Re: Freeport-McMoRan Chino Mines Company- Updated Closure/Closeout Plan Continental Mine and Hanover Mountain Mines, Permit No. GR002RE, Response to Agencies' Comments and Request for Additional Information

Freeport-McMoRan Chino Mines Company (Chino) submitted an application to renew the Continental Mine Closure/Closeout Plan (CCP), Permit GR002RE on July 31, 2023. On November 6, 2023, Mining and Minerals Division (MMD) determined the application to be administratively complete. On November 20, 2023, an interagency inspection of Continental and Hanover Mountain Mines was conducted. In a letter dated February 19, 2024, Mining and Minerals Division (MMD) requested supplemental information and submitted a combined agency review comments and Request for Additional Information (RAI) from the following state agencies: New Mexico Mining and Minerals Division (MMD), the New Mexico Environment Department (NMED), the New Mexico Department of Game and Fish (NMDGF), and the New Mexico Department of Cultural Affairs - Historic Preservation Division (NMDCA/HPD), and the New Mexico State Forestry Division (NMSFD).

I SWRDF SOUTHWEST 2
7 SECTION SCALE = 1":120'

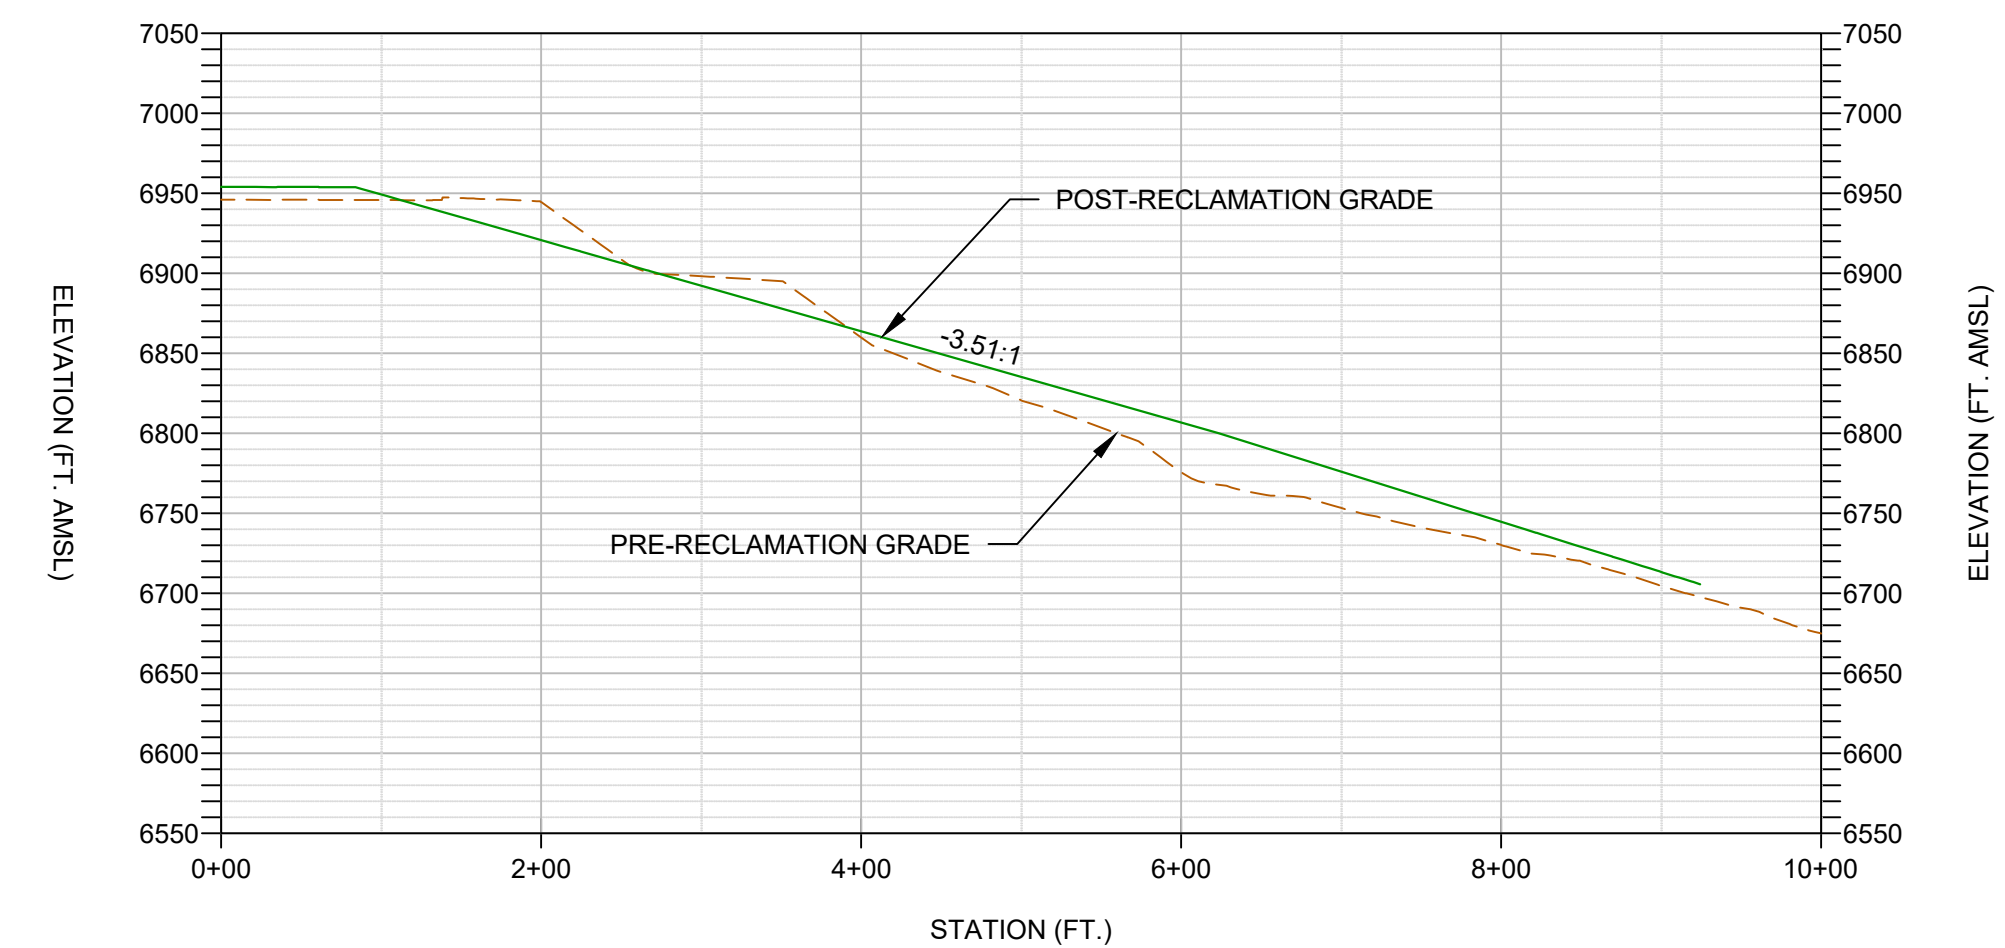
28. *Appendix E, Sheet 3 and Sheet 8. Pushdown of SWRDF crosses Fierro Road. Clarify if the pushdown will cover parts of Fierro Road, and if so, will the segment of the road be re-built.*

Chino appreciates this correction. Please see updated sheets 8 and 9.

2023 CONTINENTAL MINE CCP
REVEGETATION PLAN

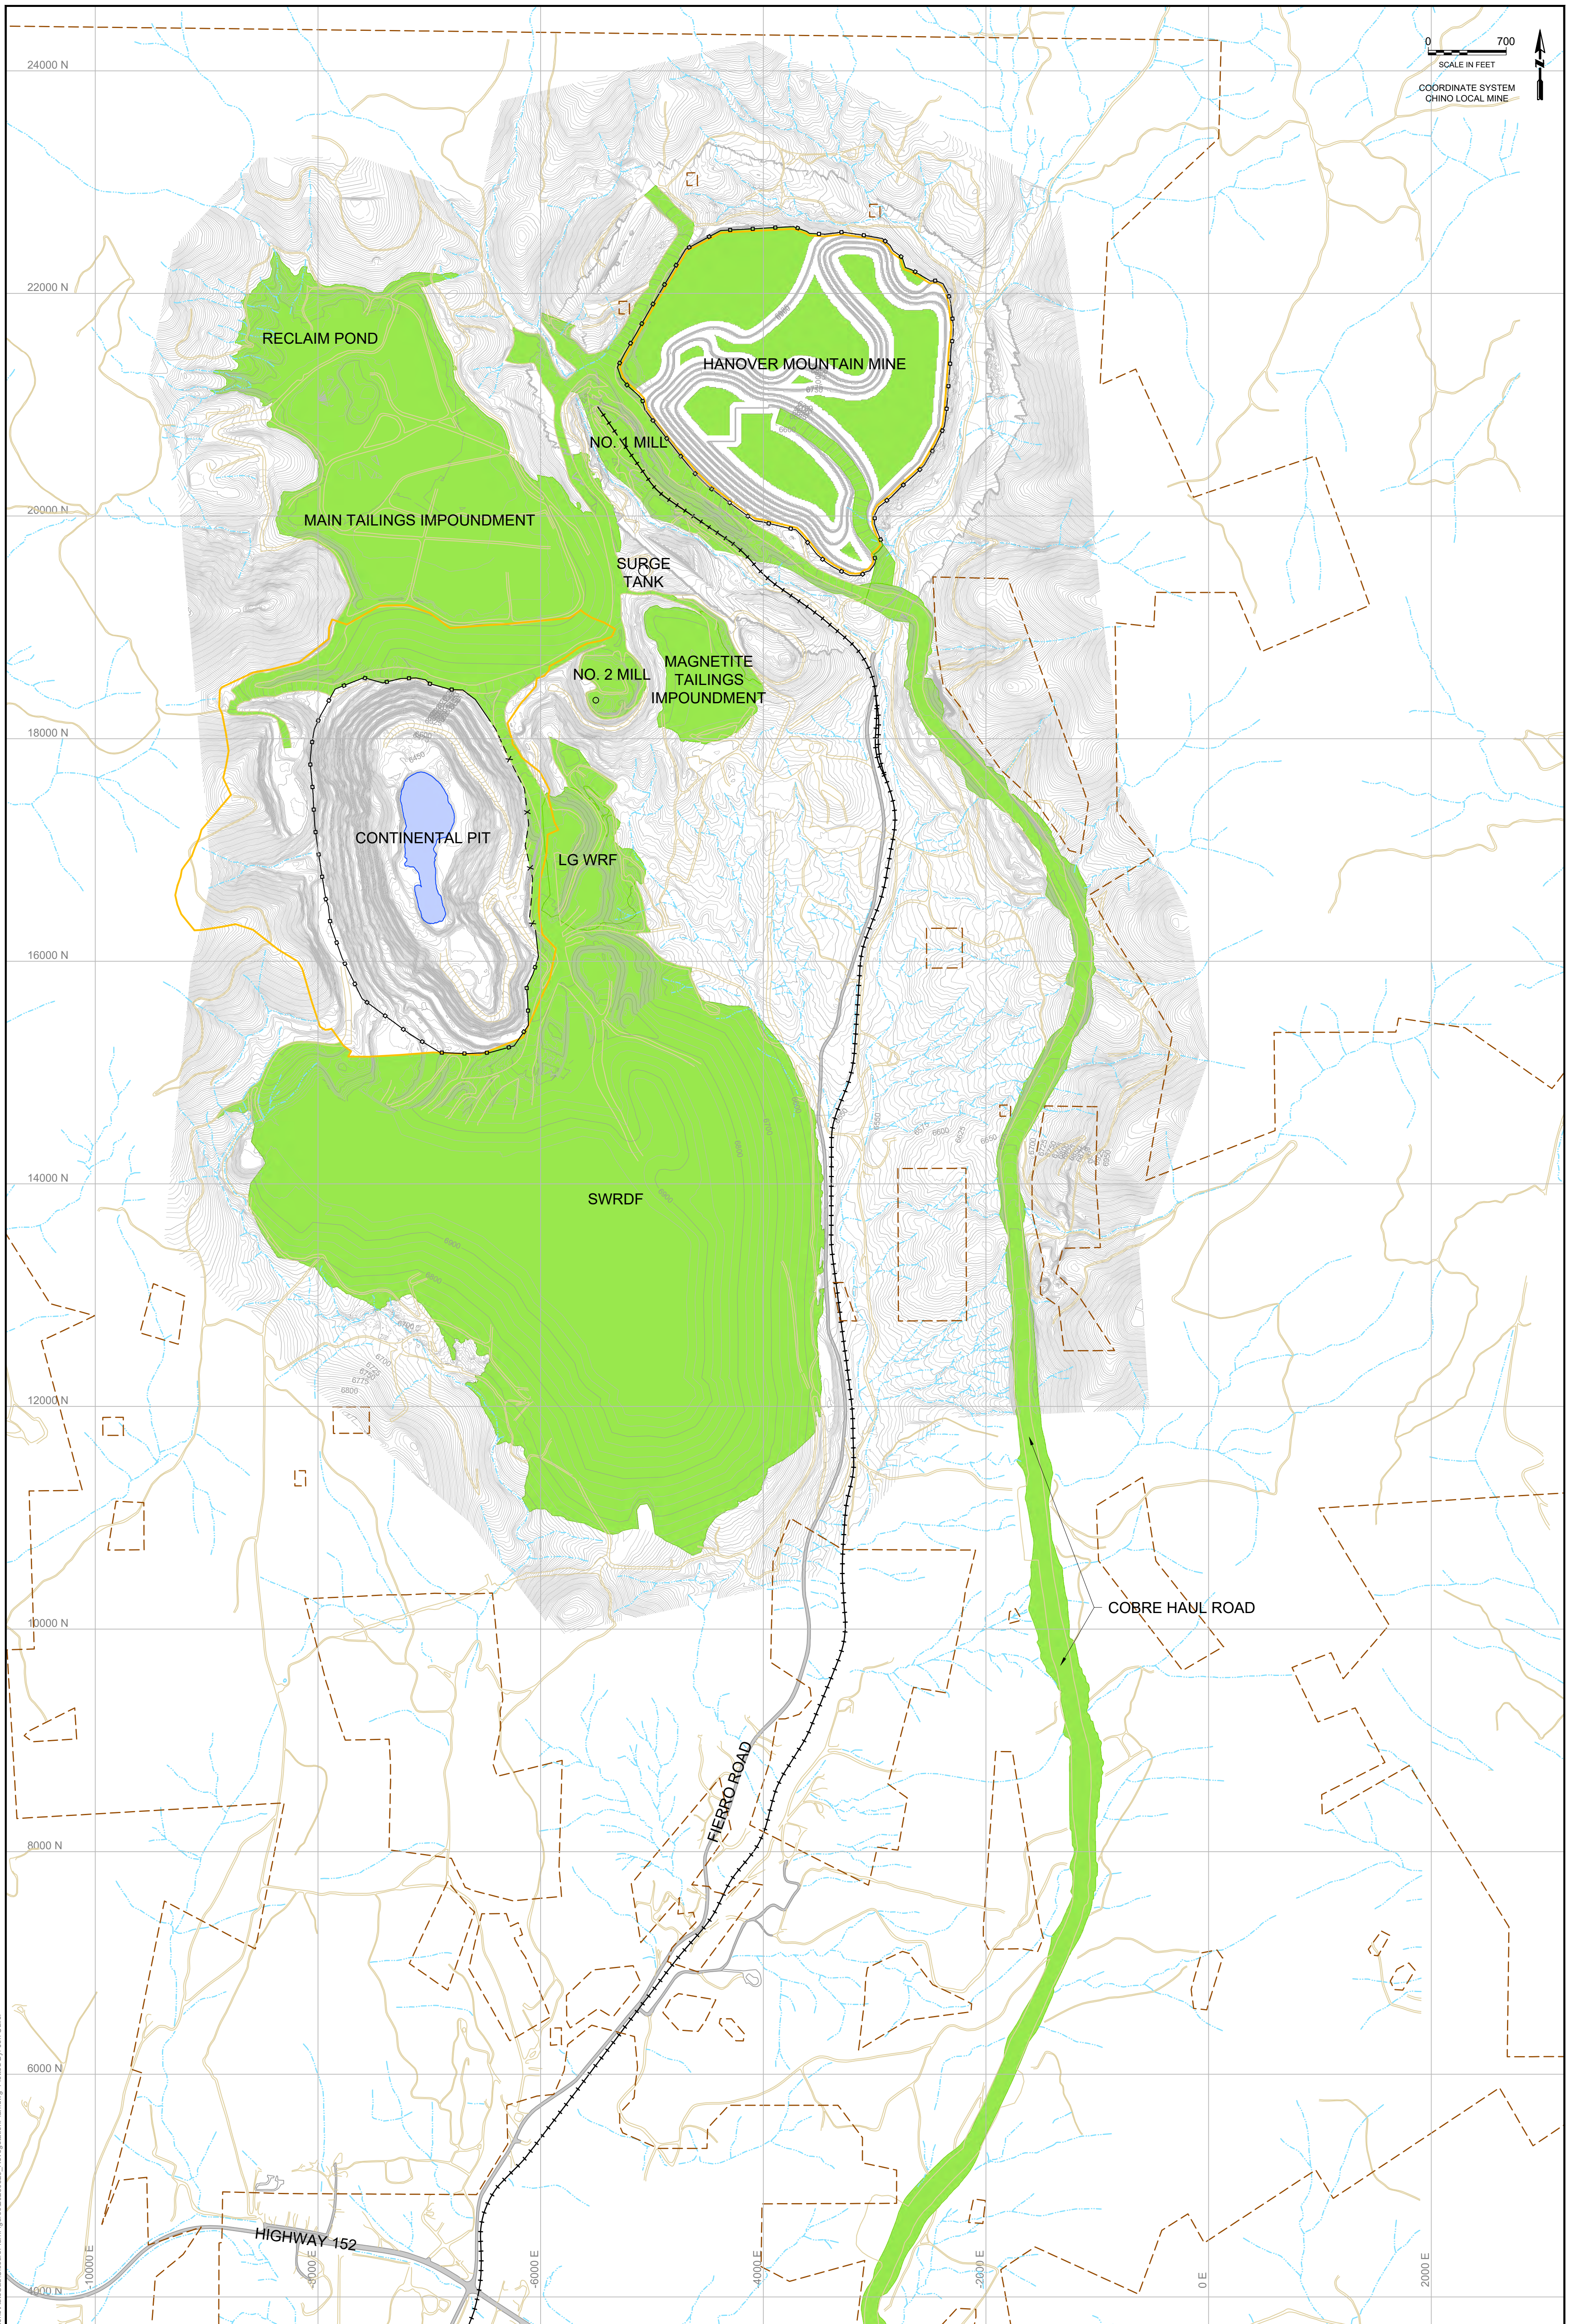
13. Page 48, Section 8.5, *Site-Specific Revegetation Success Guidelines*. Section 8.5 proposes to not meet wildlife PMLU with vegetation and proposes high walls as suitable wildlife habitat for overall SSE. The Hanover Mountain Mine Pit does not have a pit waiver, which is limited to the Continental Mine Pit. Provide map and acreage of the proposed area that will not meet the wildlife PMLU.

As in all previously approved Continental Mine CCPs, all flat areas greater than 50 feet from pit highwalls (both above and below) will be covered and revegetated. This method for closure of the Hanover Mountain

Mine Pit results in 48% of the surface area (70.7 acres) that will not meet wildlife PMLU. Sheet 24 (Appendix E, attached) shows Hanover Mountain Mine Pit revegetation areas and highwalls.
